## BOARD OF WATER SUPPLY

March 13, 2018

Subject: Review Comments – Sentinel Well Network Development Plan, Investigation and Remediation of Releases and Groundwater Protection and Evaluation, Red Hill Bulk Fuel Storage Facility, dated December 11, 2017

# Attachment A

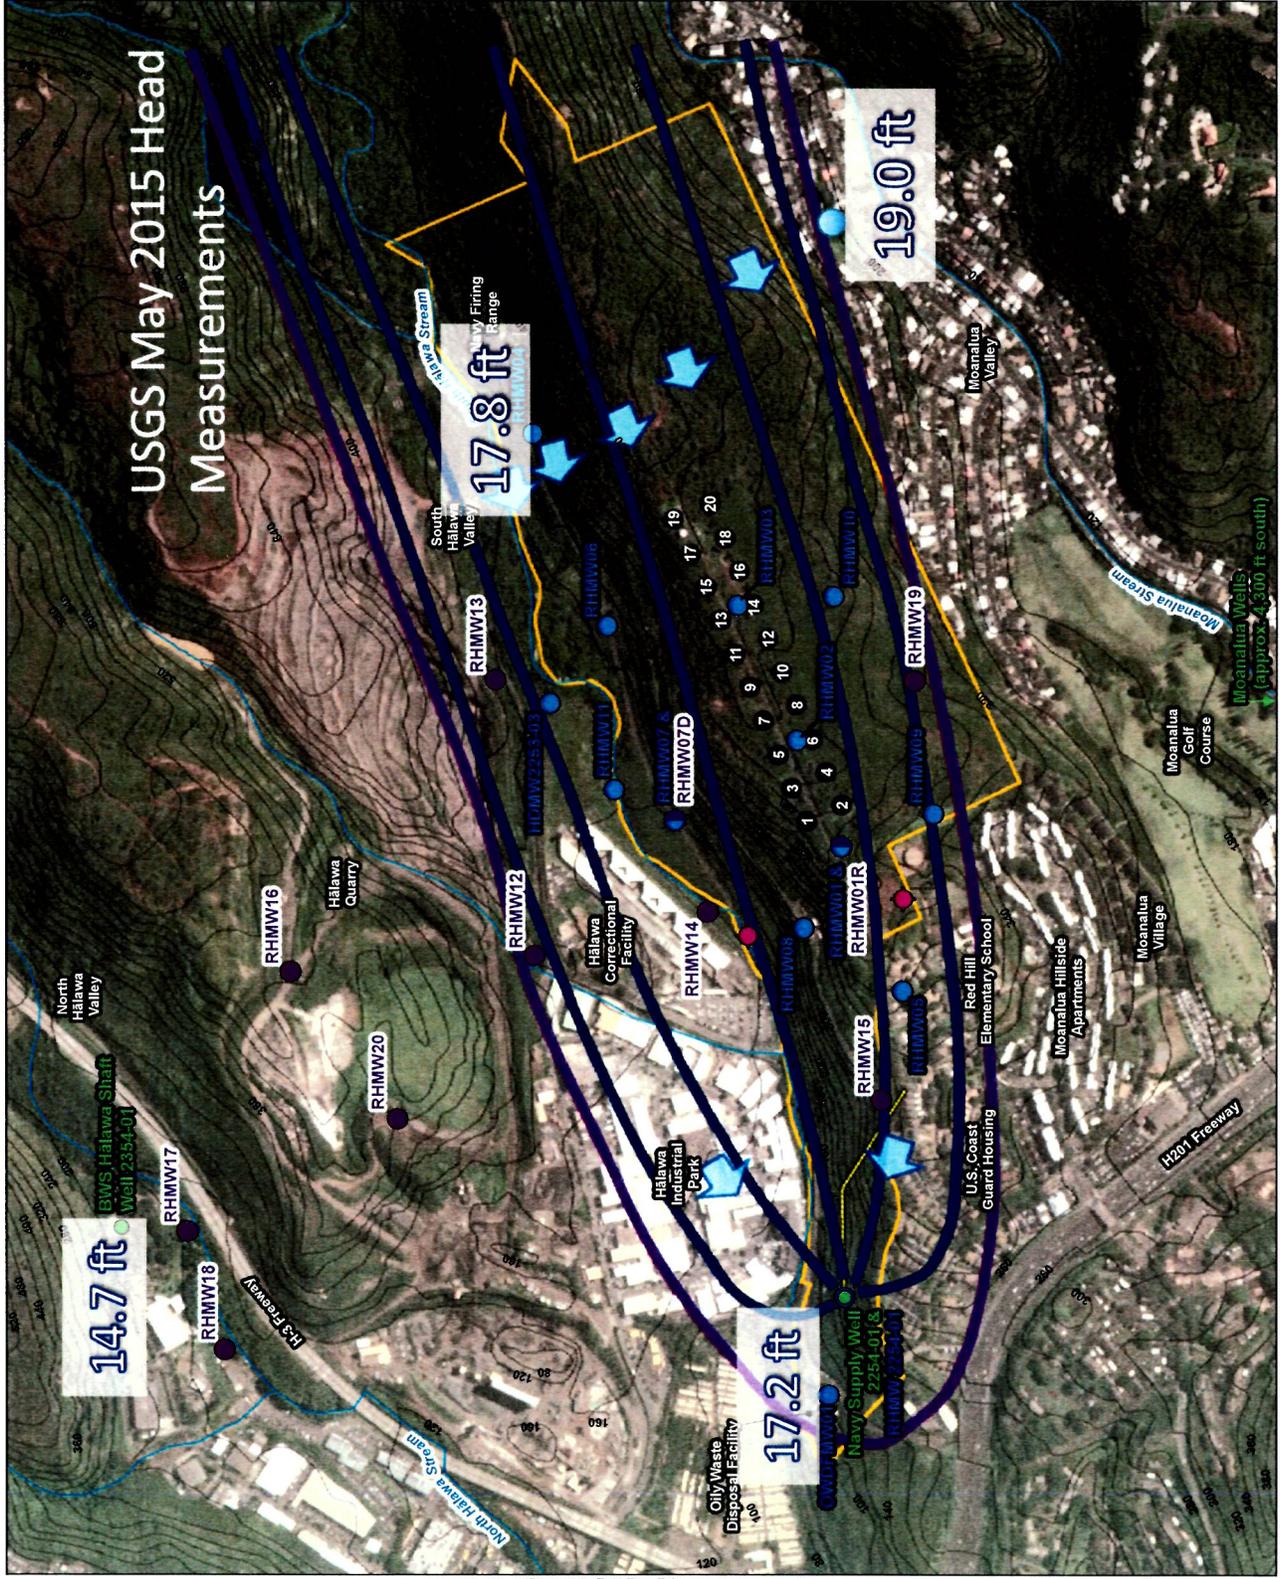
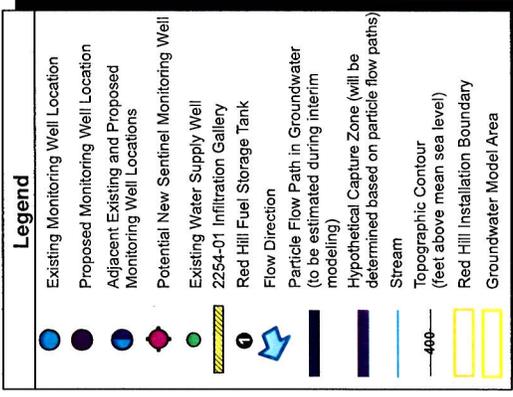
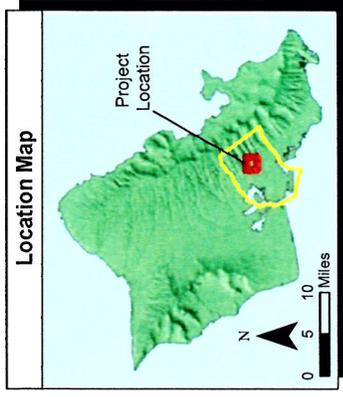
5. Section 2.6 Groundwater Model, page 14 of 24. This section states that the "groundwater flow and CF&T models and the CSM play a critical role in evaluating proposed sentinel monitoring wells". BWS is seriously concerned that the Navy's conceptual basis that it proposes to use to select sentinel well locations does not match several years of groundwater head observations. As an example, the Navy's conceptual explanation of groundwater flow depicted in Figure 5 does not match 2015 and 2016 groundwater levels reported by the United States Geological Survey. Attachments A and B to this letter overlay the

observed groundwater levels for 2015 and 2016, respectively, on the Navy's Figure 5. The Navy's hypothetical flow direction (blue arrows) directly contradicts the northwest flow direction indicated by the observed groundwater levels. The Navy's "hypothetical" flow arrows should at least reflect the observed groundwater levels from data sets that have long been available to the Navy. If the actual flow direction is from southeast to northwest, then the hypothetical capture zone from pumping at Red Hill Shaft will have a very different orientation and extent. Consequently, the BWS asks that the Regulatory Agencies to direct the Navy to honor the observed data in selecting sentinel well locations rather than using conceptual and numerical models that contradict these observations.
